Site Address: 7685 GREENHAVEN DR SAC
Parcel No: 031-0490-025

Nature of Work: TEAR OFF SHAKE AND REROOF W/LIGHTWEIGHT TILE 27 SQRS

James A. Sanders, P.E.
5330 Illinois Avenue
Fair Oaks, CA 95628
916-967-9058

Subject: Roof evaluation for 7685 Greenhaven Drive, Sacramento

PLAN VIEW OF ROOF RETROFIT
NTS

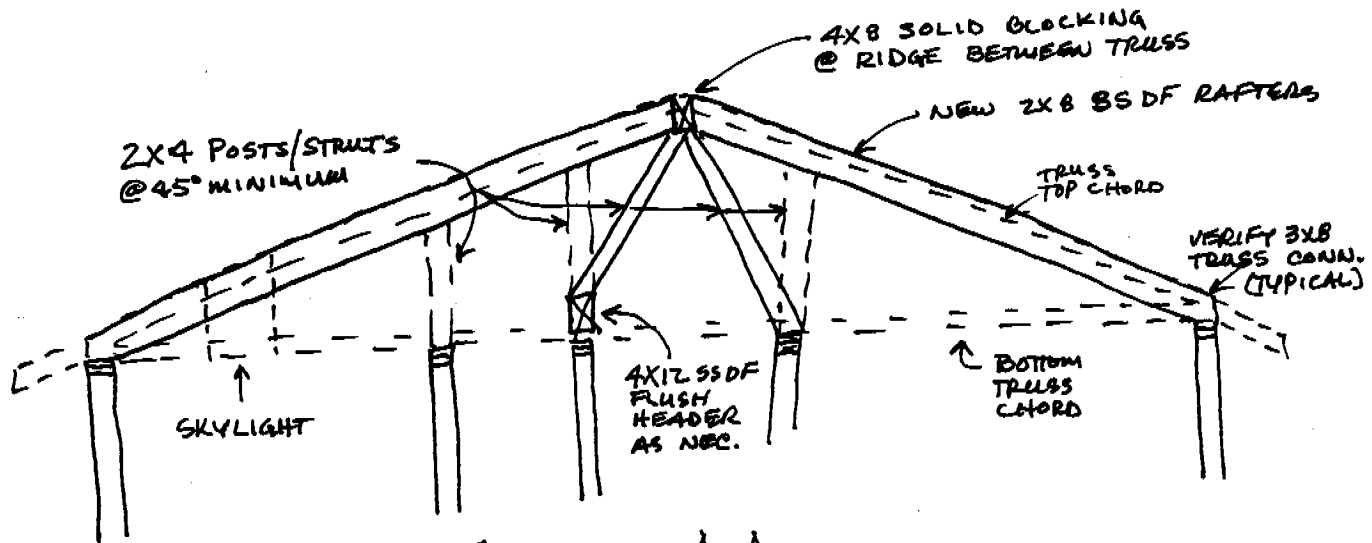
2. The Skylight in the Master bathroom ceiling was not installed properly. The Truss manufacturer provided an extra Truss to accommodate the Skylight, but the framing crew did not utilize it. The intended/proper installation would require installing a complete Truss on each side of the Skylight. Instead they "sistered" or spliced the extra Truss adjacent to the regularly spaced Truss adjacent to the Skylight, and cut the top and bottom chords of the regularly spaced Truss that conflicted with the Skylight. The altered Truss is not effective.

- ③ — Support the new 2x8 Rafters at or near the Ridge with 2x4 Posts/Struts at 45°, minimum, down to the 4x12 Flush Beam(s) and other interior Partition Walls running perpendicular to the Trusses with the intent of distributing the Roof load from the new Rafters as much as possible

- ① — 1. Manufactured Roof Trusses: Field verify (after "tear-off") that connector plates joining the top and bottom Truss chords are at least 3"x 8".
 - ② — 2. Install a 4x12 SS DF Flush Beam(s) as necessary at the Ceiling over the Master Bath supported on the southerly exterior Bearing Wall and the interior Partition Wall located approximately 13', 16', and 23' from the rear exterior Bearing Wall. Install supports under each end of the 4x12 to prevent deflection contact with the bottom chords of the Trusses. Install 2-4x8 Blocks at the Ridge between the Trusses on each side of the cut Truss. Install 2x8 #1/btr DF Rafters on each side of the Skylight [Four (4) total] from front to rear. The existing framing will provide a sufficient Tie for these new Rafters. Provide lateral support for the 4x12 Headers to prevent rotation. *Field verify that roof bearing is to a bearing wall*
